INSPECTION REPORT

Inspection Entry Date/Time	11/19/2024 09:26 AM (PT)	Announced: No	
Inspection Exit Date/Time	11/19/2024 02:10 PM (PT)	Access: Granted	
Weather	55°F, Overcast		
Media	Water		
Statute(s)/Program(s)	Clean Water Act, NPDES, Stormwater – Industrial		
Type of Inspection	Compliance Evaluation Inspection		
Permittee Name	Swanson Group Manufacturing, LLC		
Facility or Site Name	Springfield Plywood & Veneer		
Facility/Site Physical Address	1651 South F Street		
City, State, Zip Code	Springfield, Oregon 97477		
County	Lane		
Facility GPS Coordinates	44.04207, -123.005269		
Mailing Address	P.O. Box 250		
City, State, Zip Code	Glendale, Oregon 97442		
FRS ID	110001655575		
Permit Number	ORR221309		
SICs	2421 (Sawmills & Planing Mills, General) 2436 (Softwood Veneer & Plywood)		
Lead Inspector:			
Raymond Andrews	EPA Region 10	andrews.raymond@epa.gov	(206) 553-4252
Supervisor Review:			
Peter Contreras	EPA Region 10	contreras.peter@epa.gov	(206) 553-6708

I arrived at the Swanson Group Manufacturing’s Springfield Plywood & Veneer facility (the “Site” or “Facility”), located at 1651 S F St, Springfield, Oregon, at 09:26 AM (PT) on 11/19/2024 for an unannounced inspection. I pre

Site Map, photo 1			IMG-20241119104817481797970.jpg
11/19/2024 10:48 AM	No CBI	No PII	Photographer: Raymond Andrews

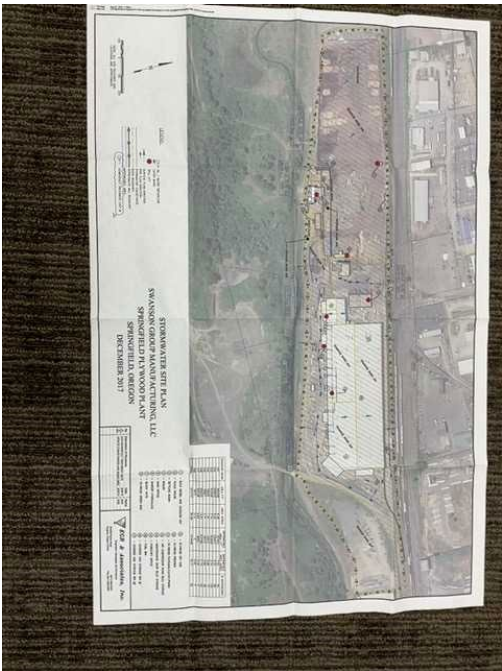
At the time of inspection, I reviewed the facility's Stormwater Pollution Control Plan (SPCP), dated June 2021. The SPCP shows the facility is under SIC code 2421 (Sawmills and Planing Mills, General) but based on activities, SIC code 2436 (Softwood Veneer and Plywood) should probably be added as a secondary activity. The facility is no longer monitoring or discharging from Outfall 5, so the map should be updated. The site plan does not indicate when packaged products are stored outside. The site plan does not show the loading and offloading areas. The site plan is missing the immediate access roads and rail lines used or traveled by carriers of raw materials, manufactured products, waste material, or by-products used or created by the facility.

AOC: The site plan did not show the loading and offloading areas. The site plan is missing the immediate access roads and rail lines used or traveled by carriers of raw materials, manufactured products, waste material, or by-products used or created by the facility.	
AOC Reference #: RA1-OB-003	Location: Outside Boiler
Permit Requirement Schedule A.1.c of the permit states, in part, "Cover all waste contained in bins or dumpsters where there is a potential for drainage of stormwater through the waste to prevent exposure of stormwater to these pollutants. Acceptable covers include, storage of bins or dumpsters under roofed areas or use of lids or properly secured temporary covers such as tarps."	
AOC: There was open dumpster that contained ash from the boiler. It did not appear the dumpster was being actively loaded or unloaded.	
AOC Reference #: RA1-OB-004	Location: Outside Boiler
Permit Requirement Schedule A.1.g of the permit states, in part, "Routinely clean all exposed areas that may contribute pollutants to stormwater with measures such as sweeping at regular intervals..."
